RWY 4R Supplemental Study Analyses

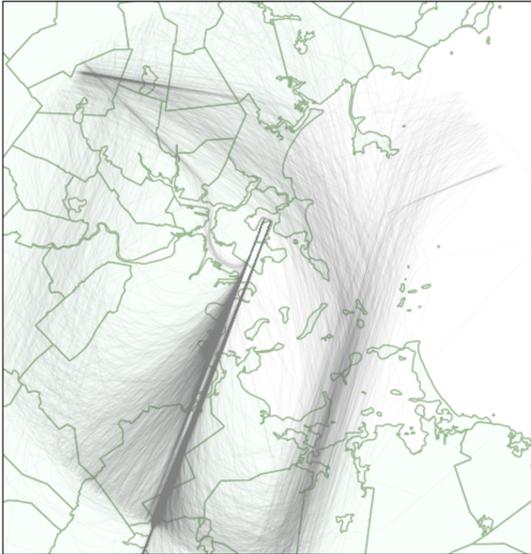
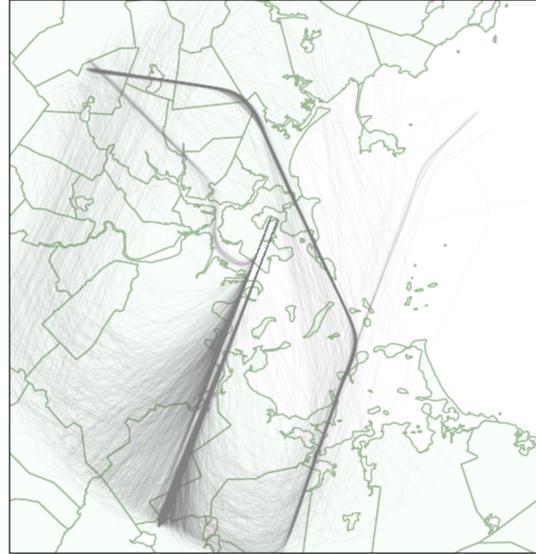
1) Please present, side by side, the attached Massport 2009 4R/4L flight tracks Slide and the attached FAA November 2020 Slide of 4L/4R RNAV path CSPRs over Milton. Thereby, allow visual a comparison of pre-RNAV 4R arrival flight tracks dispersion over Quincy and Milton with the present post-RNAV concentration over Milton of the 4R RNAV path and its proposed 4L counterpart.

KBOS 4L/4R Arrivals May 2011

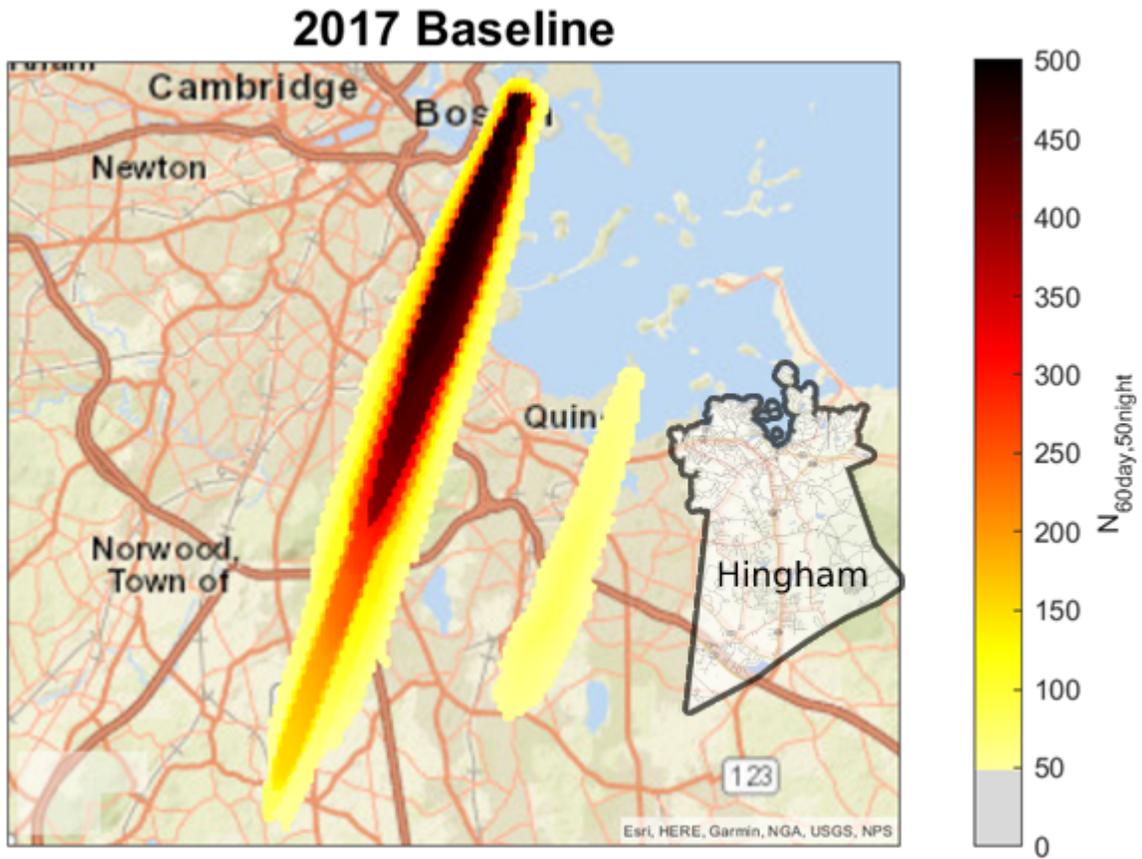
- 2) Please present the N60 peak day overflight numbers for the existing 4R RNAV over Milton, over Braintree, over Quincy and over Hingham, respectively, in order to allow comparison.
- 3) For Hingham, show any other applicable present N60 peak day numbers and identify the associated flight path(s) and altitudes.

RNAV Route 3 Initial

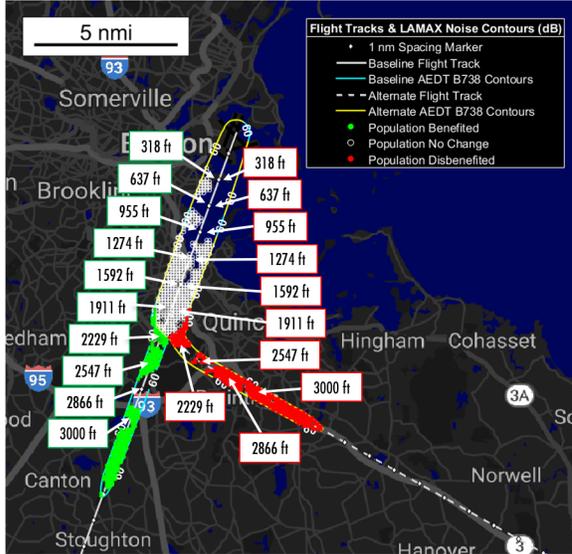
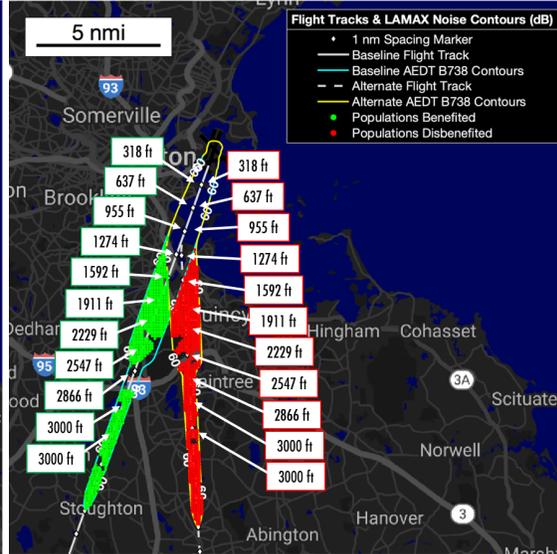
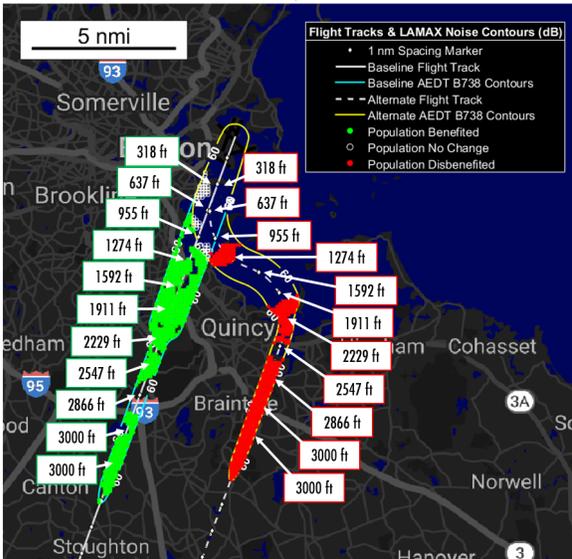
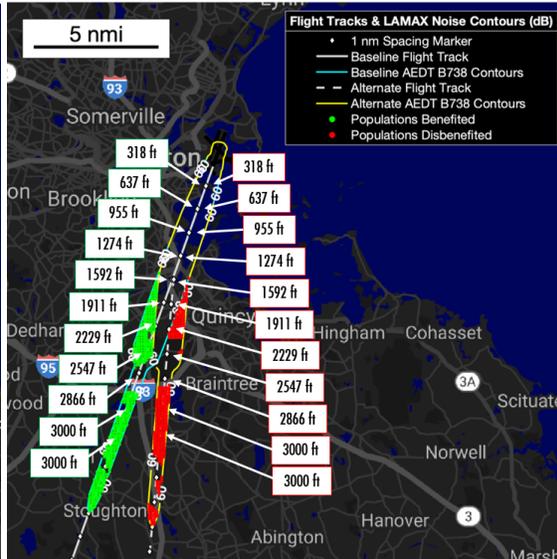
4) At Milton's request, MIT provided each of the attached three RNP Altitude charts compared with the Altitude chart for the 4R RNAV path. Please present those comparisons as part of the supplement.

5) Show the respective comparative noise effects of 3000 ft altitude, 1911ft altitude and 1592 ft altitude overflights represented in the RNP/RNAV Altitude charts.

Undertrack $L_{A,MAX}$:

Aircraft Type	3000 ft Altitude	1911 ft Altitude	1592 ft Altitude
B777 (widebody)	66 dB	72 dB	74 dB
B738 (narrowbody)	61 dB	70 dB	72 dB
